# REGULATORY INFORMATION DISTRIBUTION SYSTEM (RIDS)

SUBJECT: Forwards addl info re electrical design of containment purge valves, in response to NRC 800328 ltr. Forwards oversize elementary drawings.

May 5, 1980  
LDR-80-129

This letter is in response to your letter of March 28, 1980 regarding additional information concerning the electrical design of the containment purge valves.

# FIGURE 1

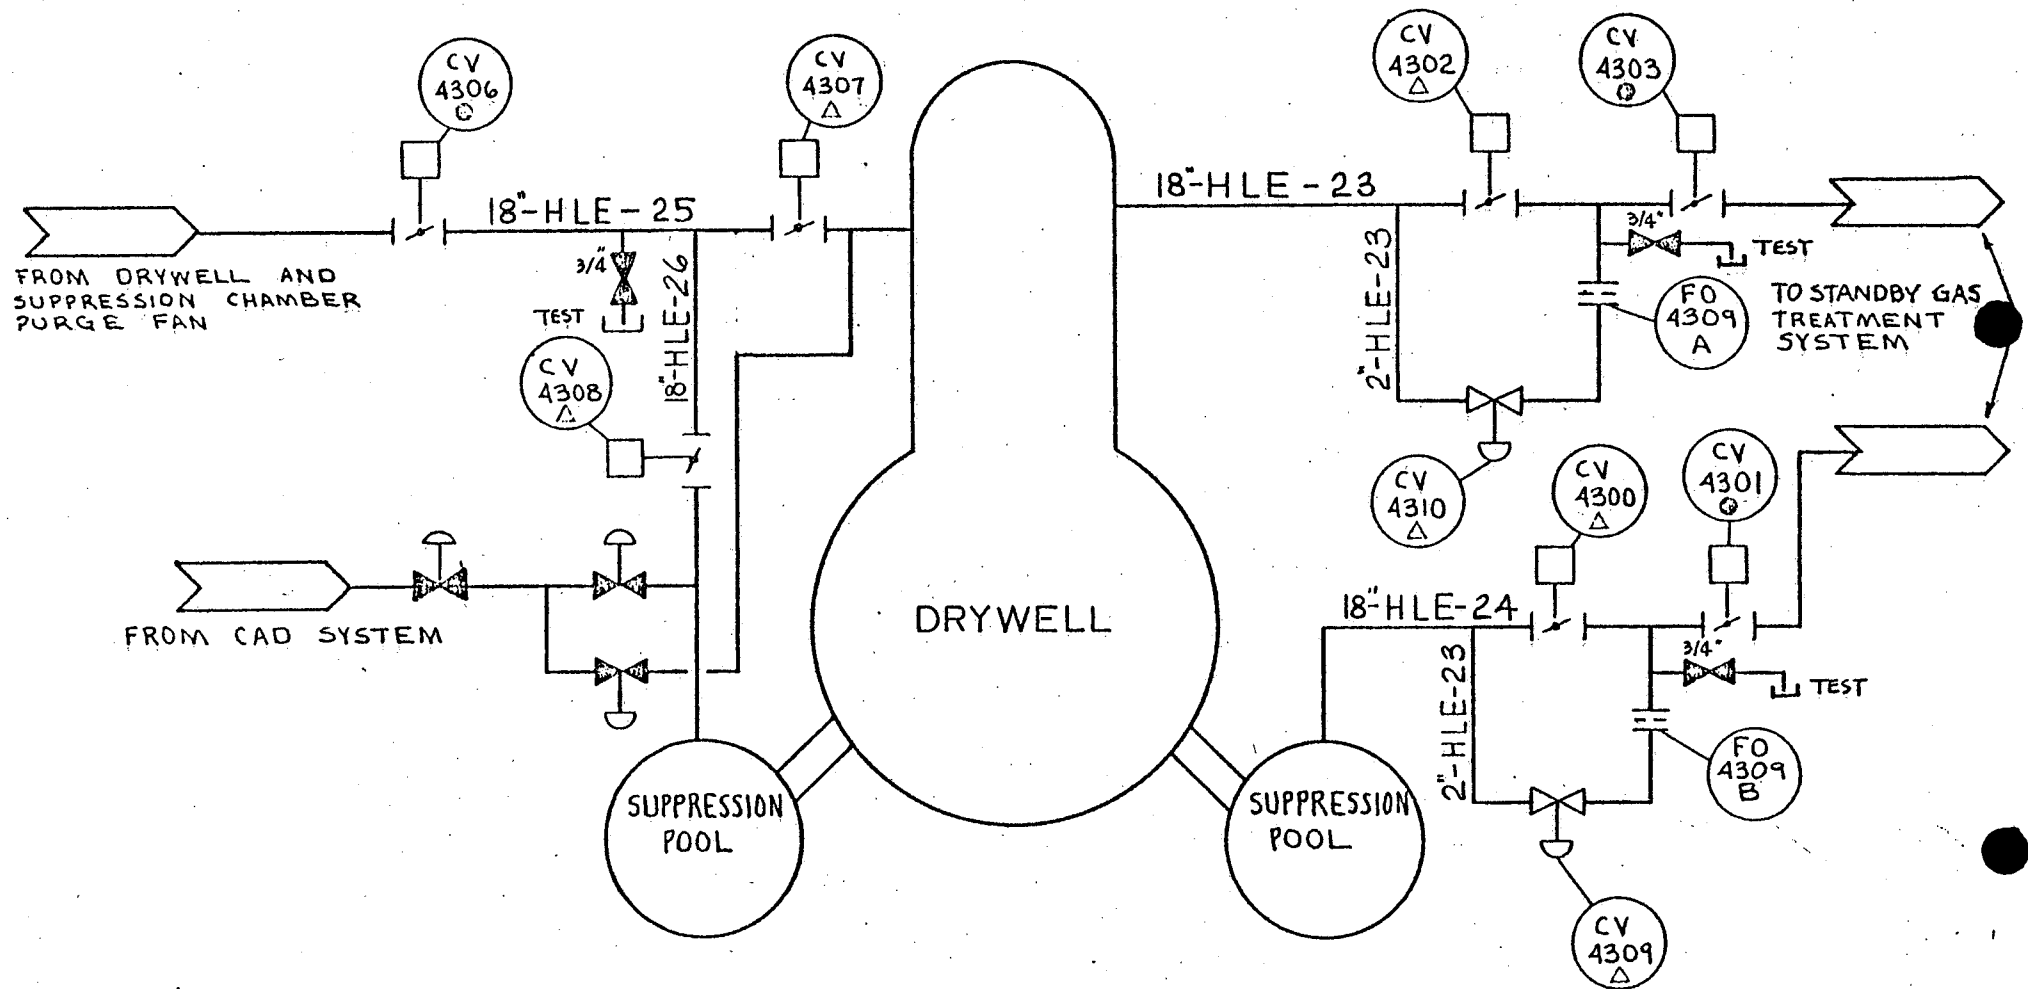
In keeping with the requirements of General Design Criteria 55 and 56, the overriding of one type of safety actuation signal (e.g., radiation) should not cause the blocking of any other type of safety actuation signal (e.g., pressure) for those valves that have no function besides containment isolation.

As shown in Figure 1, the DAEC containment purge and vent isolation system contains 9 valves, arranged in 3 groups of 3 valves each. Each grouping consists of an outboard isolation valve and 2 inboard isolation valves. One group provides containment isolation of the purge supply line, one group isolates the drywell ventilation exhaust line, and one group isolates the suppression pool exhaust line. The outboard valves are isolated by electrical division 2 isolation circuitry, whereas the inboard valves are associated with division 1 isolation circuits. The purge and vent valves automatically isolate on any one of the following plant conditions:

As we indicated in our letter of December 14, 1979, the override circuitry for the subject valves has been modified to satisfy Criterion 1. Specifically, the containment isolation logic for these valves now provides individual override capability of each isolation parameter without the bypassing of the remaining parameters, such that the valves will isolate if any non-overridden isolation parameter is exceeded. With this design modification, Criterion 1 is satisfied by the ability of the purge and vent valves to reisolate following an isolation/override/reopen valve sequence and the subsequent occurrence of a second (or third or fourth) trip parameter.
